A RESOLUTION ADOPTING FINDINGS OF FACT, APPROVING A REQUEST FOR TENTATIVE MAP FOR HAGGINWOOD GARDENS (APN: 251-311-11) (P-9447)

SUBJECT: Special Permit and Tentative Map to develop 32 Townhouses

LOCATION: Northwest corner of Pamela Drive and Diamond Avenue

Haggin wood Gardens
A Patio Garden Flanned Development
By Robert Frank & Regency Developers Ltd.

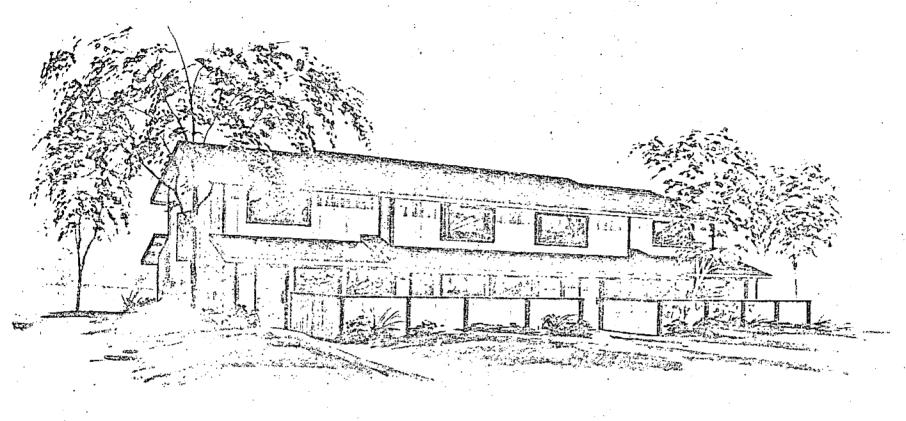
The applicant has submitted a revised tentative map indicating 30 units and a reduction of two units. Staff believes the changes made adequately address the concerns expressed by staff and the Planning Commission. The applicant has addressed the major concerns which included density reduction, elevation revision, site design, compliance with the 80 percent north/south policy and vehicular circulation improvement. However, staff has the following comments with regard to the current proposal:

- 1. For adequate summer window shading, a three-foot roofline overhang is necessary. Building elevations should indicate this overhang.
- 2. The parking area and interior street circulation must be shaded to comply with current solar regulation (50 percent shaded surfaced area within 15 years). Most shade trees require at least a sixfoot wide planter area. The applicant should keep this in mind when selecting landscaping materials. Planters along the roads may require widening.

- 3. In order to provide some variety of design, staff suggests that the units be staggered along the street frontages. Staff also suggests that the exterior elevations be reviewed by the Architectural Review Board. The Board should address the following:

- a. The side elevation for design relief; and
 - b. Provide visual interest to the front and rear elevations
- 4. The Planning and Community Services Departments have determined that .300 acres of land are required for parkland dedication purposes and that fees are to be charged in lieu of the required parkland dedication. The subdivider shall submit to the City an appraisal of the land to be subdivided. Said appraisal shall be dated and submitted no more than 90 days prior to filing the final map. Fees shall be paid prior to filing the final map with the City Council.

- 1. Ratification of the negative declaration;
- 2. Approval of the special permit based on findings of fact and subject to conditions which follow below:
- 3. Approval of the tentative map subject to conditions which follow: Conditions - Special Permit
 - a. The applicant shall submit the exterior elevations to the Architectural Review Board for review and approval. ARB suggestions shall be incorporated into the building plans.
 - b. Detailed landscaping and irrigation plans, including surfaced area shading, shall be submitted for review and approval by the Planning Director prior to issuance of building permits.
 - c. Building plans shall indicate three-foot roof overhangs.

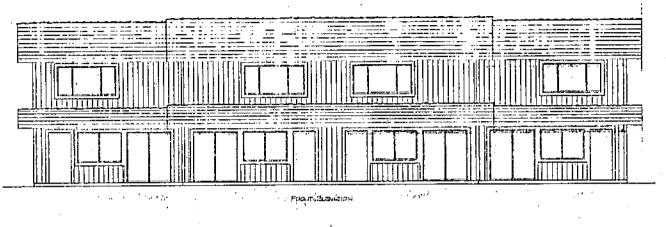
Subsequently, the applicant submitted revised elevation and floor plans. The only change that was made is the units were offset by three feet instead of two feet. The revision resulted in very little change of the elevation. They appear almost identical to the original elevations. Also, the applicant made no attempt to redesign the site plan to meet the 80% north/south policy, to improve the vehicular circulation and useable open space.

Staff believes the change that was made did not address the concerns expressed by staff and the Planning Commission, therefore, cannot support the project.

Staff recommends another continuance in order to allow the applicant time to redesign the overall project to address the concerns expressed in the staff report.
